**FIRST AMENDMENT  
TO  
CONSTRUCTION SERVICES AGREEMENT  
BETWEEN  
THE TOWN OF FOUNTAIN HILLS  
AND  
BARBAGALLO ELECTRIC, LLC**

**Change Order No.:** 2012-101.1

**Name of Project/Contract:** Fire Station Emergency Generators

Fire station 2

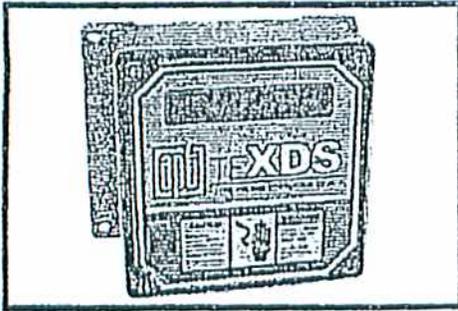
DESCRIPTION	AMOUNT
Provide and install two 200 amp surge protectors. One for each panel which will protect entire building and generator. Material- \$1,400, labor- \$500 Thank you for the opportunity to bid this project, Vince Barbagallo, Barbagallo Electric	
SUBTOTAL	\$1,900
SALES TAX %	%
SALES TAX	\$190
TOTAL	\$2,090

Fire Station 2

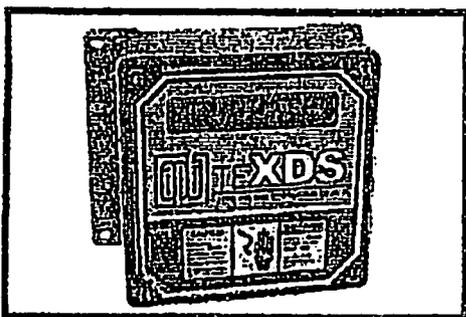
DESCRIPTION	AMOUNT
Provide and install two 200 amp surge protectors. One for each panel which will protect entire building and generator. Material- \$1,400, labor- \$500 Thank you for the opportunity to bid this project. Vince Barbagallo, Barbagallo Electric	
	SUBTOTAL \$1,900
	SALES TAX % %
	SALES TAX \$190
	TOTAL \$2,090
